PUBLIC INTEREST REVIEW FOR GROUNDWATER APPLICATIONS

TO: Water Rights Section Date 08/17/2016
 FROM: Groundwater Section Phillip I. Marcy
 SUBJECT: Application G- 18320 Reviewer's Name Supersedes review of
 Date of Review(s) _____

A. GENERAL INFORMATION: Applicant's Name: John & Kathryn Rohner County: Baker

Figure 1: A Theis time-drawdown calculation predicts that impacts at the closest neighboring groundwater POA will be greater than 100 feet of drawdown over a period of 245 days at 4.0 cfs.

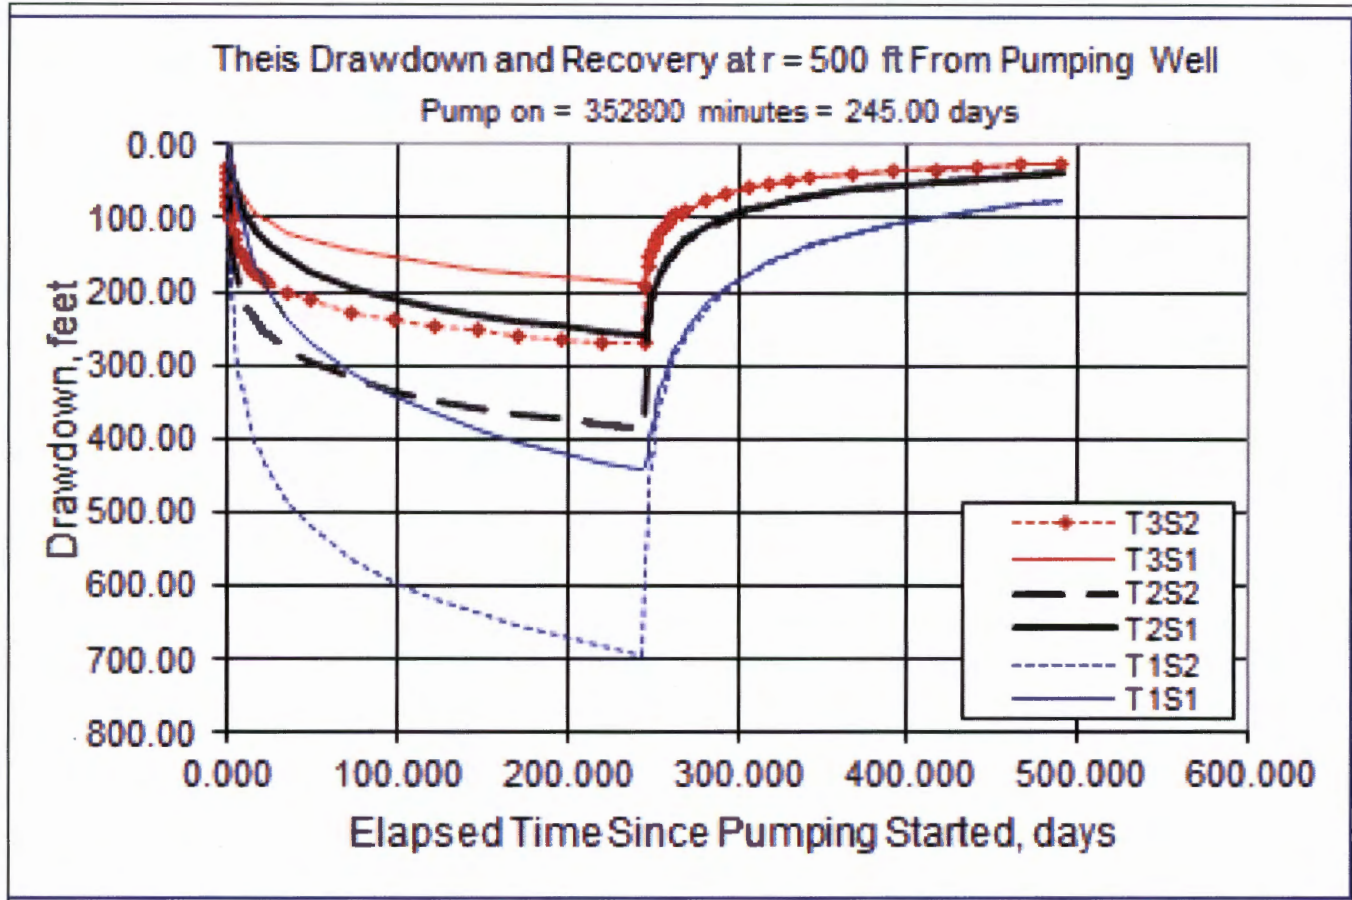
B3. **Groundwater availability remarks:** The proposed location for POA 2 on this application is 500 feet away from the authorized POA well for groundwater right Certificate 34416. All three of the POA wells on this application are proposed to produce from alluvium, which according to our conceptual understanding of this area, will also be within the same aquifer system as the authorized POA under Certificate 34416. At this distance, at a pumping rate of 4.0 cfs, the expected impacts due to pumping over the course of one irrigation season are greater than 100 feet (Figure 1). This projection was calculated using the time-drawdown method of Theis, with aquifer parameters determined from local pump tests. To avoid injuring nearby senior right holders, the applicant may consider producing from the deeper volcanic bedrock aquifer in the area. It will be important, however, to avoid drilling into older metasedimentary rocks mapped by Brooks and others (1976), as these rocks commonly yield little water.
